March 13, 2015

Re: Fourth Preliminary Site Plan Review
Butterfield Redevelopment Site
NYS Route 9D, Cold Spring, NY

Barton & Loguidice, D.P.C. (B&L) has completed a fourth technical review of the following reports and information for the Butterfield Redevelopment Site located at 1756 NYS Route 9D as prepared by Site Design Consultants. We have prepared the following site plan review comments based on the following information provided to date:

RE: Butterfield Redevelopment Project - Water & Sanitary Sewer Utility Drawings and Engineer's Report

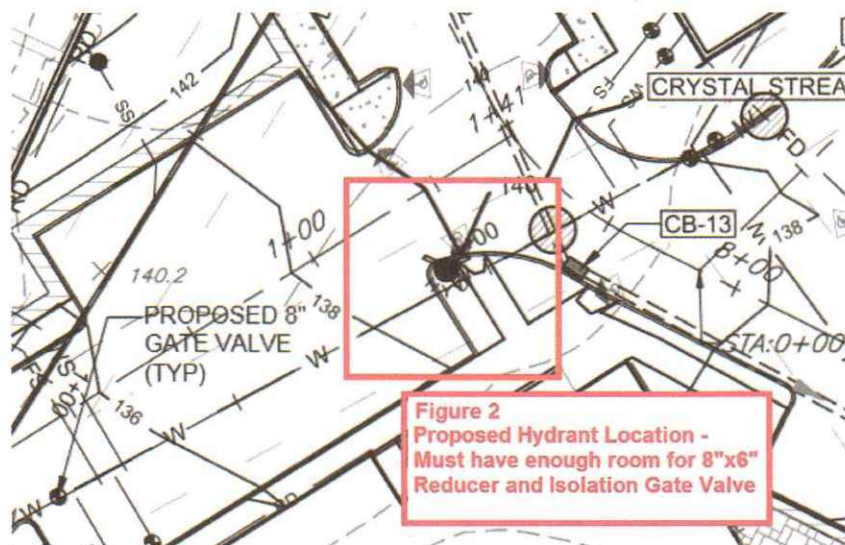
Engineer's Report, Page 2 of 6, Paragraph 2, Sentence 7: "The existing water service to the Butterfield Hospital building which connects to Paulding Avenue will be abandoned cut and capped." - I did not see a call-out for this work on C-102: Existing Conditions and Demolition Plan. There was however, citation of the current 2" copper service to the Lahey Pavilion. I would like to see the existing Paulding Avenue connection, shown in reference to the 6"x 6" tapping Tee will be installed for the new 8" D.I.P. service (see Figure 1).

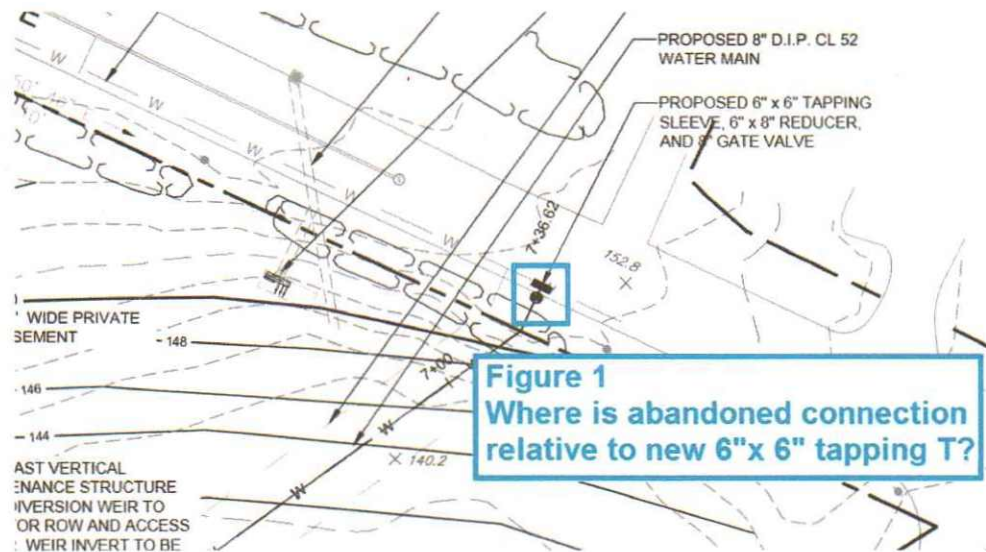
Page 3 of 6, Paragraph 3, Sentence 5: "In addition to the main, there will be two new hydrants installed and connected to the new main..." – While one of the hydrants' location was indicated with a side note, the other was not. I did eventually find it and my only concern is that the hydrant appears to be very close to the 8" main - there must be enough room for an 8"x6" reducer or hydrant Tee and isolation gate valve for the installation to be acceptable (Figure 2).
